Three Mile Island Nuclear Station, Unit 2 (TMI-2)
License No. DPR-73
Docket No. 50-320
No. 2 Personnel Air Lock Contamination Control
Facility Design Descriptions

NO. 2 PERSONNEL AIR LOCK
CONTAMINATION CONTROL FACILITY

DRAWING CHANGE NOTICE

JOB NO.	DRAWING NO.	REV. NO.
13587	2-A-810-1	0
DCN NUMBER	PAGE	OF
2-A-810-1-1	1-3

FLOOR PLAN
EL. 305'-0" SCALE 1/4" = 1'-0"

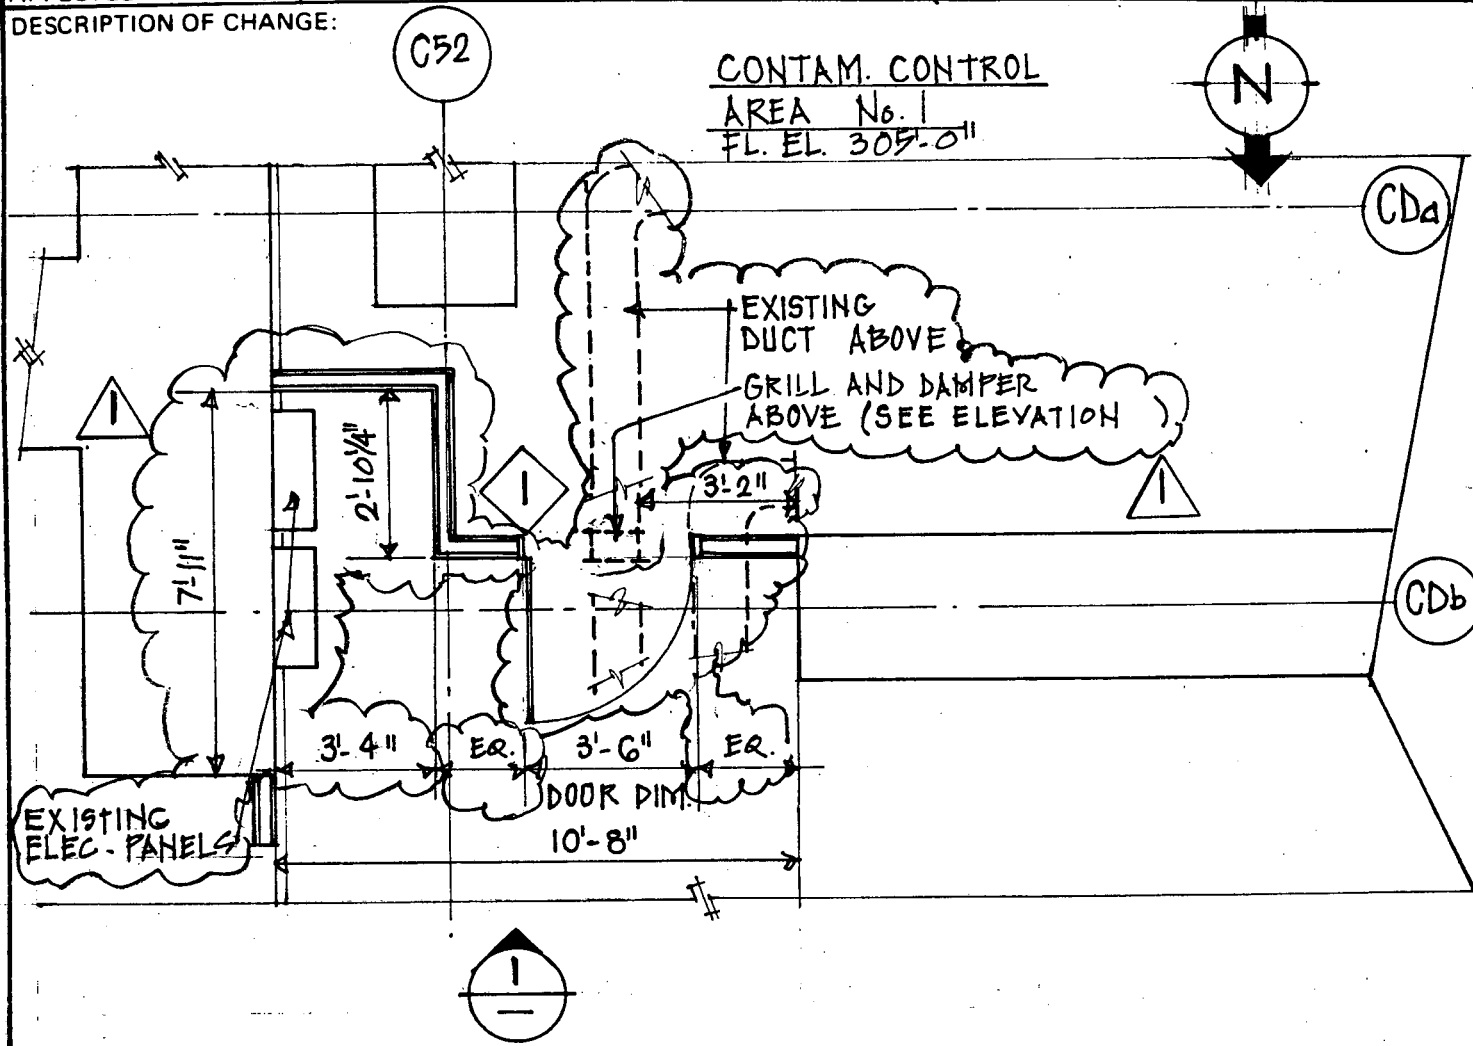
REASON FOR CHANGE: GYPSUM BOARD WALL INTERFERES WITH ELECTRICAL PANEL
